THE CITY OF KEY WEST  
PLANNING BOARD  
Staff Report

Meeting Date: September 16<sup>th</sup>, 2021

Application: **1012 Howe Street – (RE# 00026830-000000)** – A request for variances to the maximum building coverage, maximum impervious surface, and the minimum open space ratio to construct a detached accessory structure on property located within the Historic Medium Density Residential (HMDR) zoning district pursuant to Sections 90-395, 122-600 (4) a., 122-600 (4) b., and 108-346 of the Land Development Regulations of the Code of Ordinances of the City of Key West, Florida.

JULIA STREET  
*Existing Site Plan*

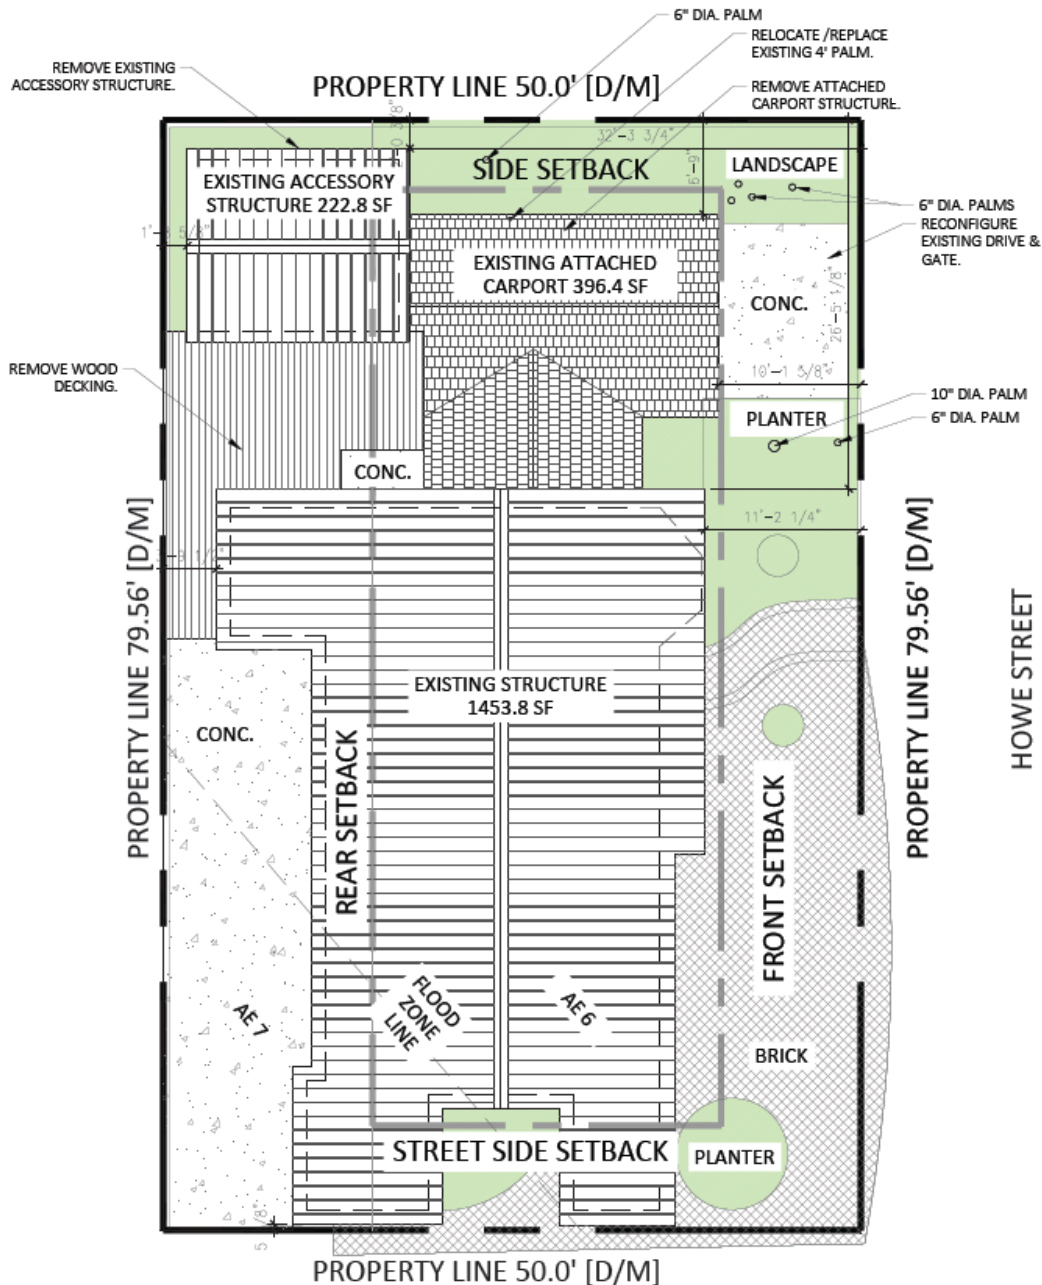
The subject property at 1012 Howe Street is located on the corner of Howe Street and Julia Street and is one lot of record. The parcel includes the following structures: a 1,453.8 square foot one-story single-family residence, an attached 396.4 square foot carport, and a 222.8 square foot accessory structure. The property is located within the Historic Medium Density Residential (HMDR) Zoning District. The applicant is proposing to remove the existing accessory structure, attached carport, wood decking, and slab of concrete in the driveway. The applicant is requesting to construct a new larger detached accessory structure and a ramp to the side and rear of the property, and install concrete parking strips to create a 9'x18' parking space.

PROPOSED SITE PLAN

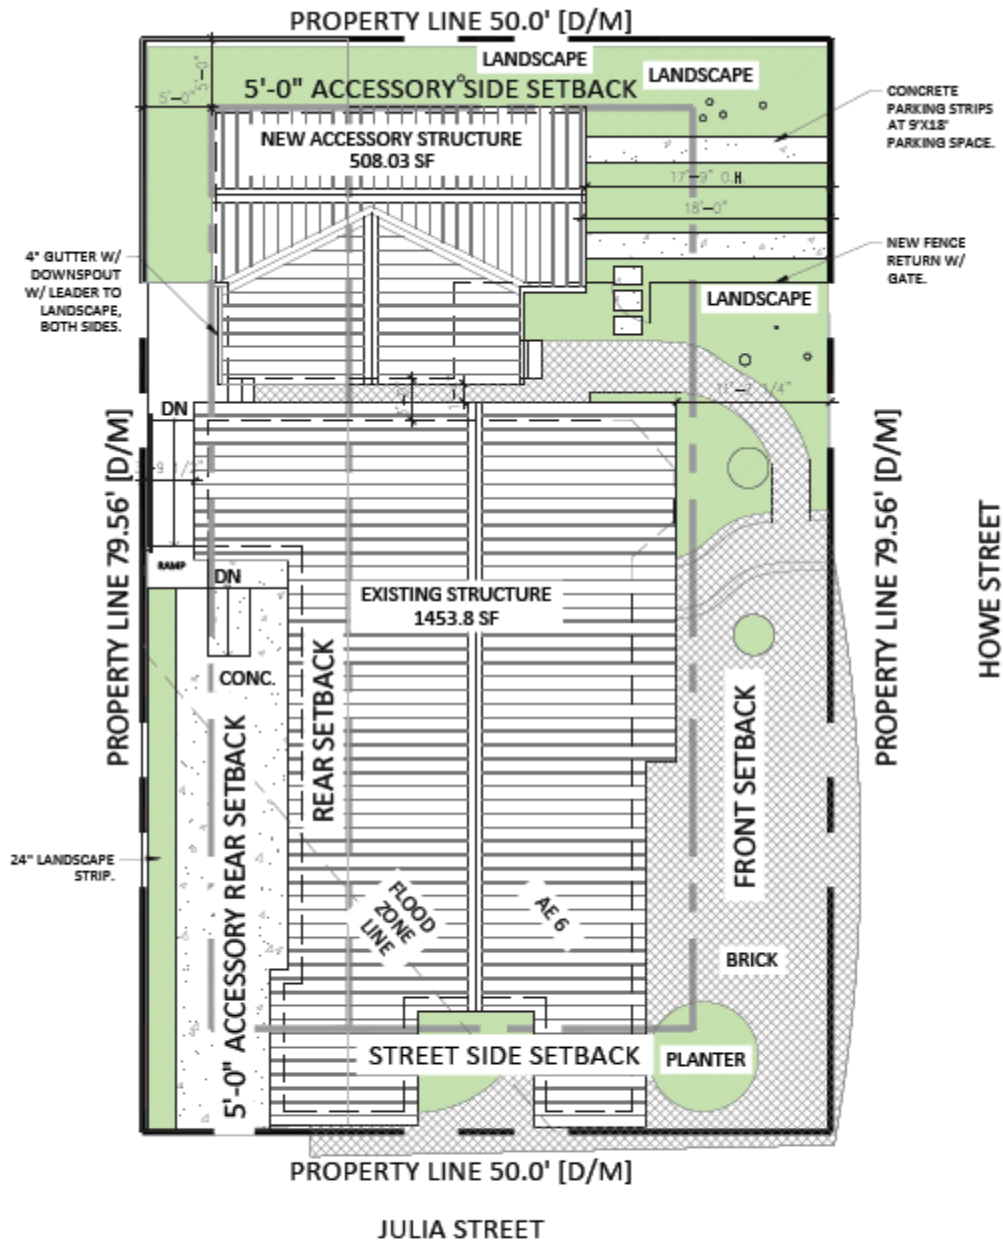
- The required maximum building coverage in the (HMDR) zoning district is 40%, or 1,591.2 square feet. The existing building coverage is 52.11%, or 2,073.04 square feet. The applicant is proposing 49.3%, or 1,961.83 square feet. The applicant has proposed to reduce the noncompliance of this standard by approximately 3%.

- The required maximum impervious surface ratio in the (HMDR) zoning district is 60%, or 2,386.8 square feet. The existing impervious surface ratio is 82.1%, or 3,268 square feet. The applicant is proposing 77.7%, or 3,092.5 square feet. The applicant has proposed to reduce the noncompliance by approximately 4%.

- The minimum open space ratio is 35%, or 1,392.3 square feet. The existing open space ratio is 17.8%, or 710 square feet. The proposed open space ratio is 22.3%, or 885.5 square feet. The applicant has proposed to improve the noncompliance of this standard by approximately 4%.
